Our ref: LTR-SEE-I-10-33 Rev. 1

Subject: **Transmittal of Responses to NRC Request for Additional Information Re: Pressurized Water Reactor Owners Group Bases For Licensee Debris Generation Assumptions for GSI-191**

The non-proprietary responses to the reformatted questions in Reference 4 have been generated and are transmitted by this letter for submittal to NRC (Attachment 1). Proprietary references, along with appropriate affidavits of withholding, will be submitted under separate transmittal.

Figure 5-1
 Schematic for Wyle Hot Water Blowdown Test Facility

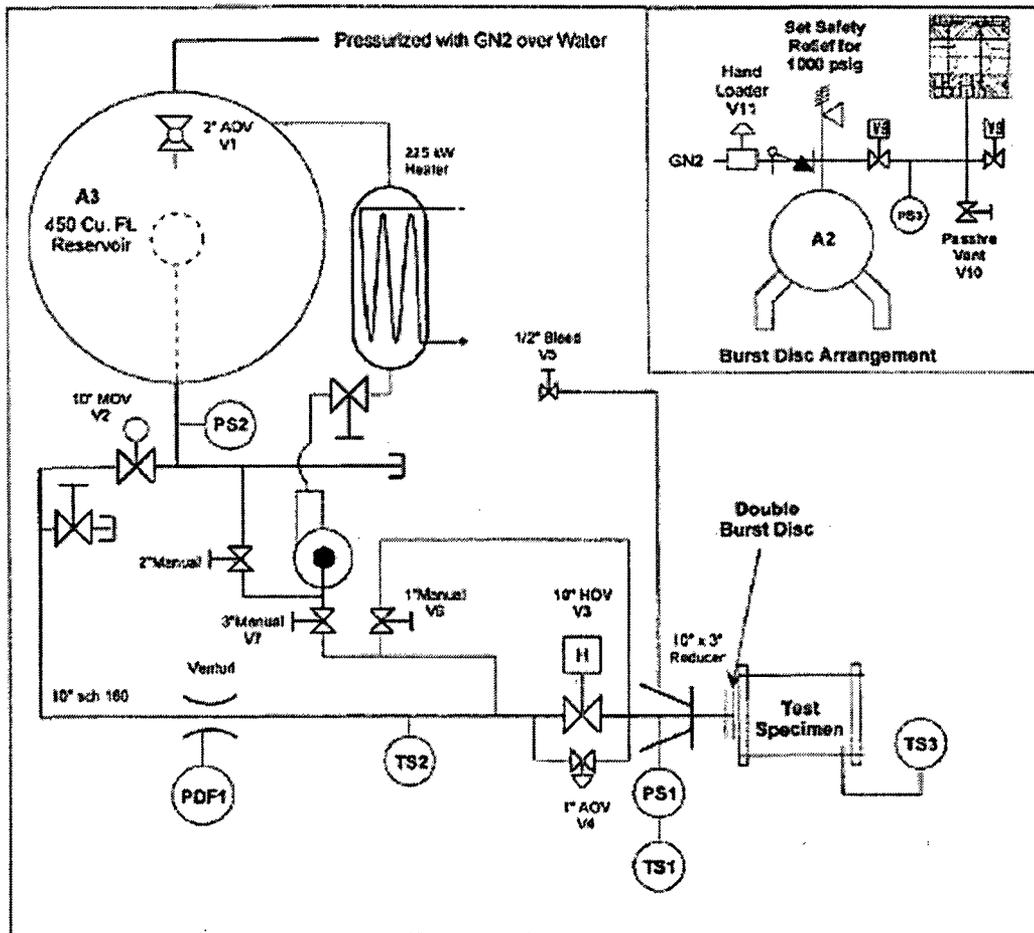
Provide a detailed description of the test apparatus specifically including the piping from the pressurized test tank to the exit nozzle including the rupture disk system.

Resolution To Issue #5:

The tests were performed at the Hot Water Blowdown Test Facility at Wyle Laboratories (Huntsville, Alabama). A schematic is given in Figure 5-1.

Figure 7-1
Reactor Pressure Vessel Top Head Panel

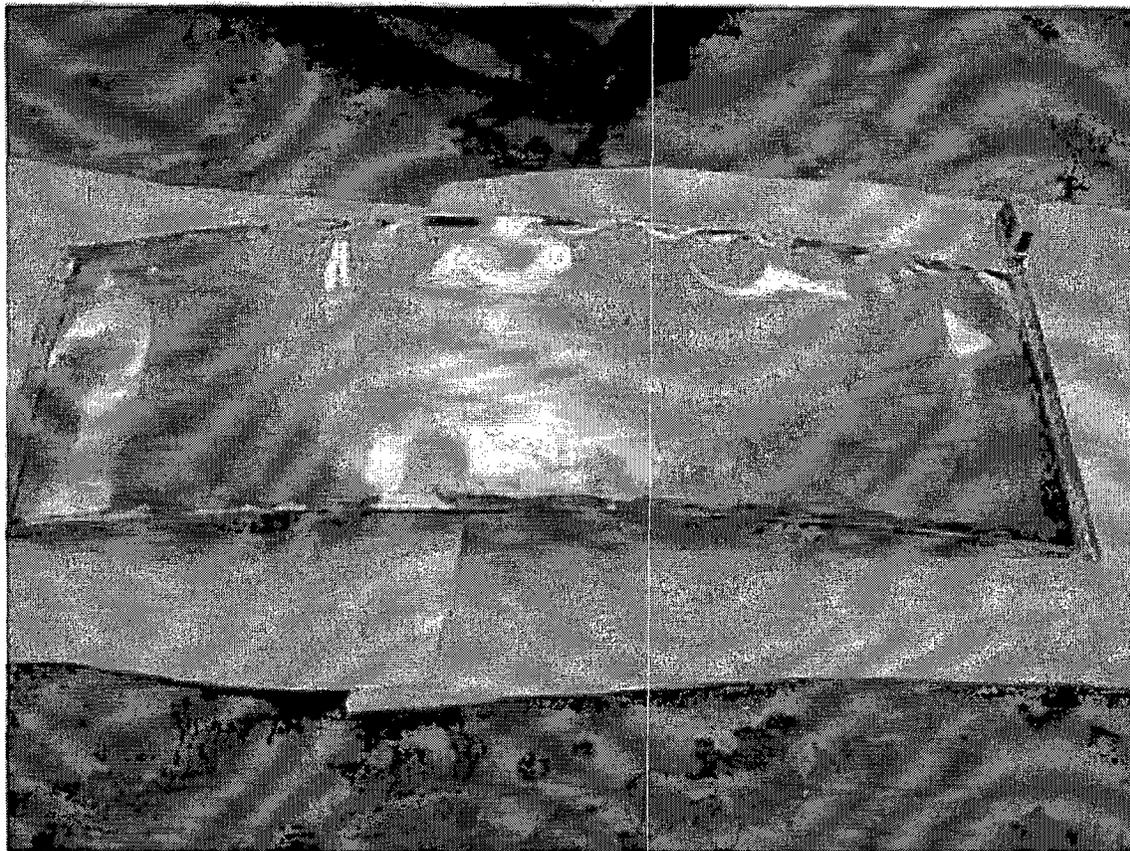
ISSUE #7 Staff does not accept PWROG position that jet-ejected insulation panels during a LBLOCA would not be damaged due to subsequent collisions in the plant. Staff position is that containment conditions are significantly more crowded than the test conditions. Therefore more damage would occur to ejected insulation in the plant than the minor damage observed during the PWROG testing.

The following text describes the ejected panel and its test configuration. This panel was 19 inches in height and had a slight curve to it. The inside surface of the panel was approximately 56.5 inches wide. The outside surface of the panel was approximately 57 inches wide. Figure 7-1 shows the reactor pressure vessel top head panel as it was received at the test facility. What appear to be “buckles” in the stainless steel encapsulation in Figure 7-1 is not damage due to shipping, handling or testing; rather it is normal buckling of the panel due to the manufacturing process.
